METROPOLITAN GOVERNMENT OF NASHVILLE AND DAVIDSON COUNTY

STAFF RECOMMENDATION
120 Second Avenue South
April 19, 2017

Application: New construction - infill (Revision to application approved in 2015)

District: Broadway Historic Preservation Zoning Overlay

1 West (Second Avenue) Elevation

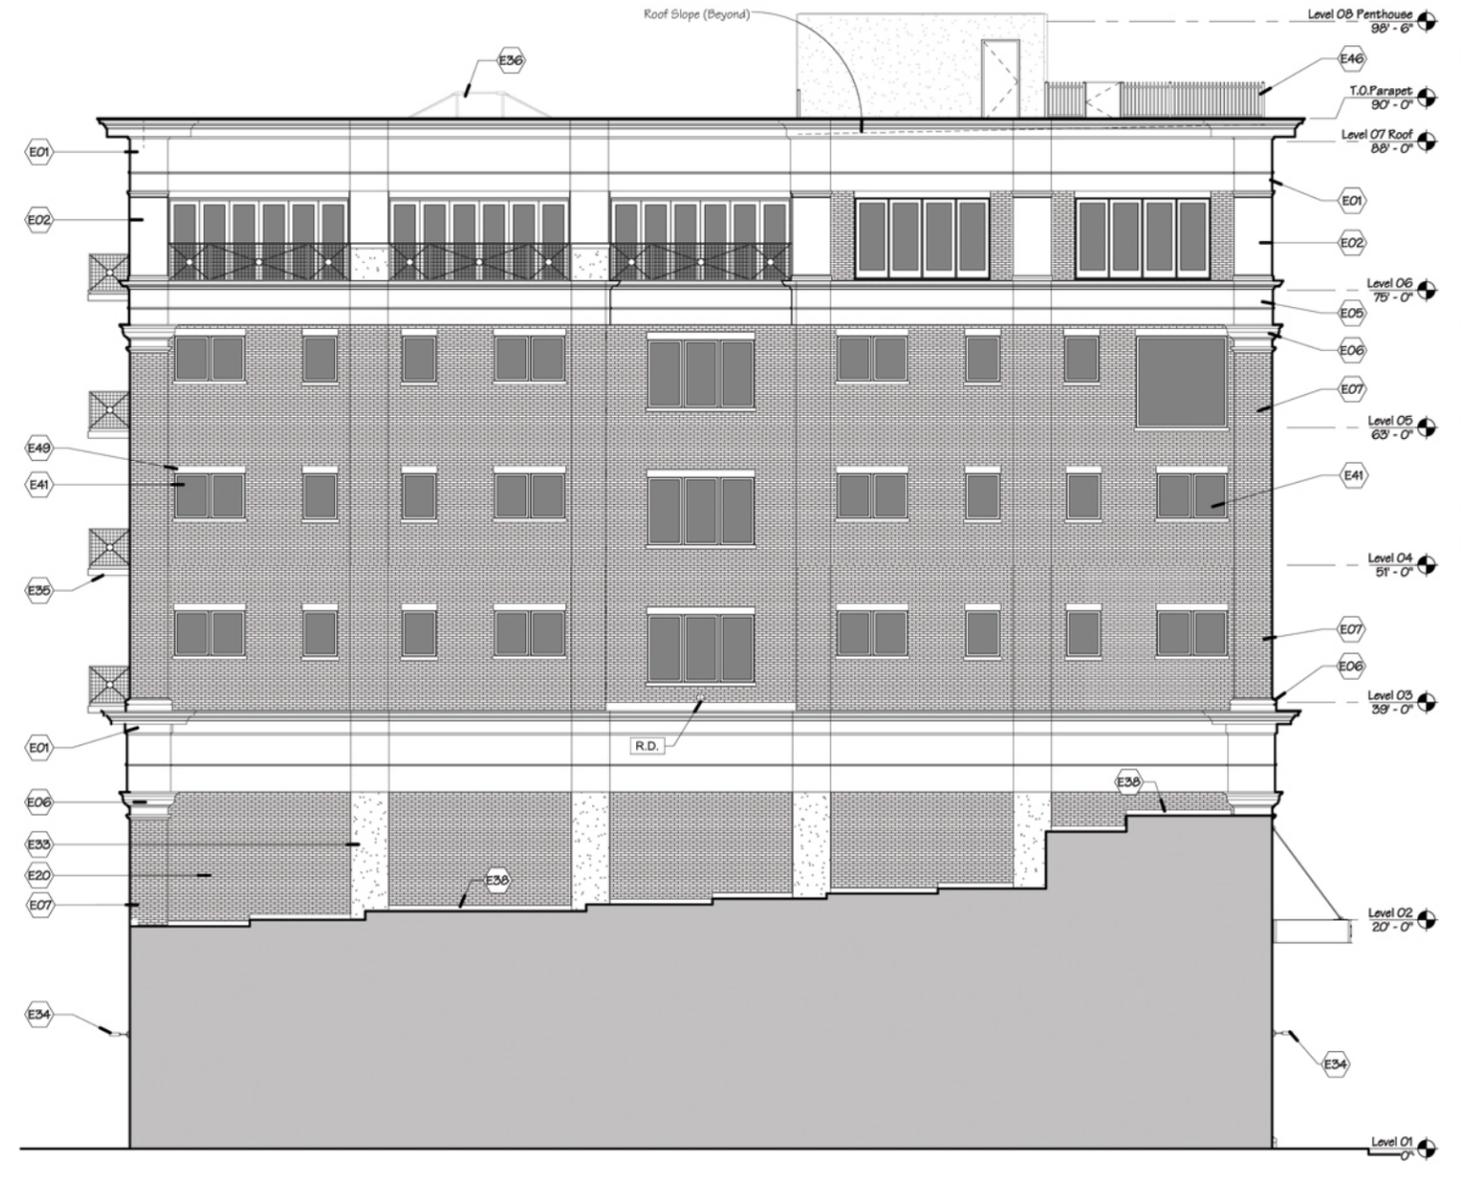
Height: The new building as approved in 2015 was proposed to be six stories tall, with a cornice height of eighty-seven feet (87') above the sidewalk level. The revised plans are still for a six story building but with a cornice height of ninety feet (90'). Since the lot is more than two-hundred feet (200') from Broadway, the maximum height allowed is ninety feet (90').

The most significant difference in designs between the approved design and the revised proposal is in the proportions of the buildings' major components. The original design had a first story storefront with a four foot (4') tall cornice topping at twenty-two feet (22') above the sidewalk. The revised proposal, by comparison, would have a first story and mezzanine, with a five foot (5') tall cornice topping at thirty-nine feet (39').

Proportion and Rhythm of Openings, Orientation: The orientation will itself not change but the new design has three double doors with side lights rather than two doors, like the original design. In addition, there is a lower bulkhead below the first level windows than originally approved. Staff finds these proportions to meet section III.E and the orientation to meet section III.G of the design guidelines.

2 South (Right Side) Elevation

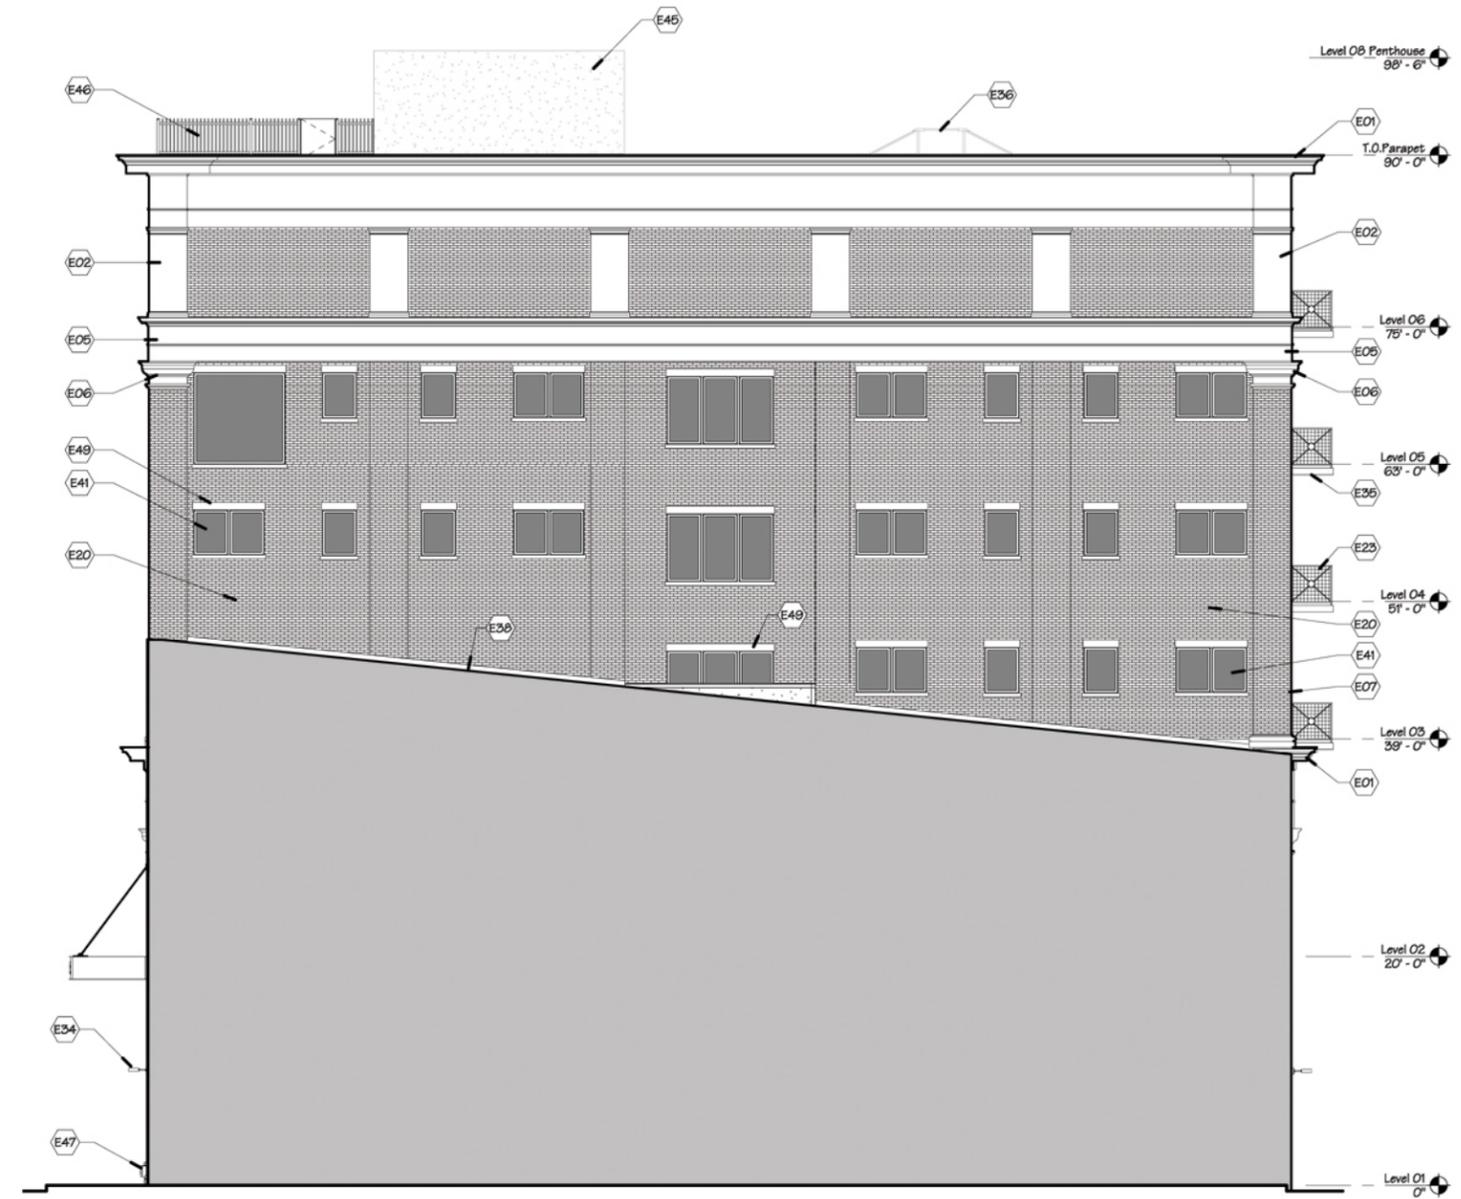
The majority of the materials will stay the same; however, the new proposal includes EIFS for the top two cornices and the right-side wall. Generally, EIFS does not meet the design guidelines; however, staff finds it to be appropriate for the top floor because of its minimal use. It is not appropriate as the cladding of the right-side wall, as section III.F.2, specifically notes EIFS as an inappropriate material. The front, right and rear sides are noted as brick; however the right side is noted as “brick patterned EIFS.” Staff recommends the right-side be all brick.

With the condition that the side wall be brick, to match the rest of the building, and that the applicant seek final review of masonry and mortar, windows and doors and lighting, staff finds the project to meet section III.F of the design guidelines.

- The right wall shall be brick to match the rest of the building;
- Staff approves final approval of materials: masonry and mortar texture, color and tooling, wall cladding, windows and doors, and lighting.
